UNITED STATES PATENT AND TRADEMARK OFFICE

| APPLICATION NO. | FILING DATE | FIRST NAMED INVENTOR | ATTORNEY DOCKET NO. | CONFIRMATION NO. |
|---|-------------|----------------------|---------------------|------------------|
| 10/519,116 | 08/10/2005 | Mark Bigley | 4990-106 US | 9475 |

| Office Action Summary | Application No. 10/519,116 | Applicant(s) BIGLEY ET AL. | |

DETAILED ACTION

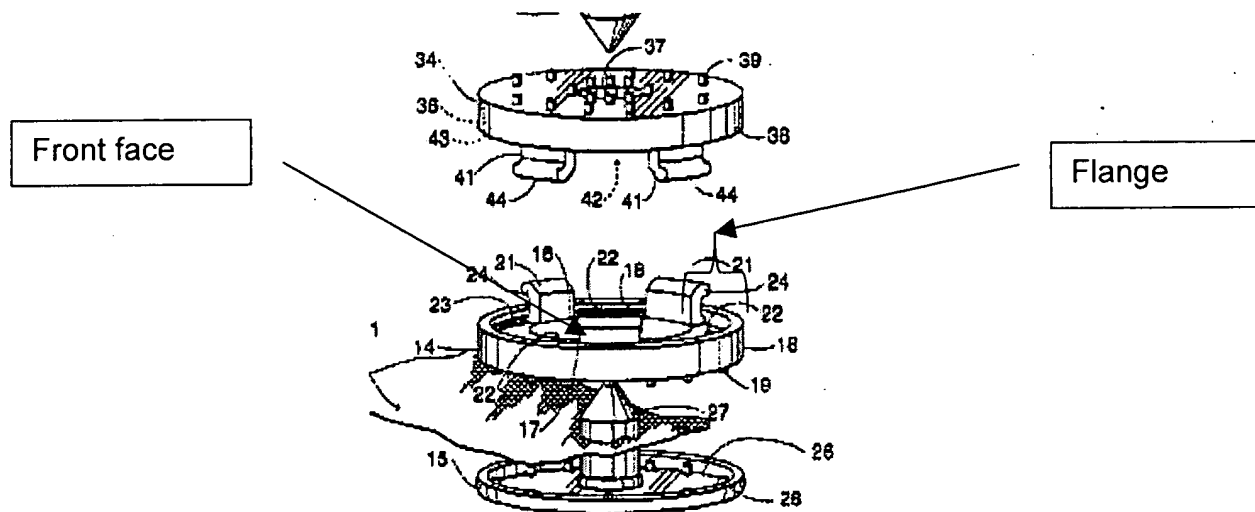
Lyle discloses a male stud (18) of a snap fastener comprising a flange with a means of attaching (28) said flange to fabric material (11); the flange having a cylindrical or annular shaped wall (22) extending axially therefrom, the wall comprising a plurality of circumferentially extending engaging portions (21), each engaging portion being separated from the next engaging portion by a circumferentially extending non

engaging portion. Said non engaging portion constitutes the part of the wall in between said engaging portions. (see below).

Lyle further discloses at least one engaging portion extending radially outwards. Also, said engaging portion is arcuate in shape. Further, said non-engaging portion comprises of a flat face and U-shaped recess.
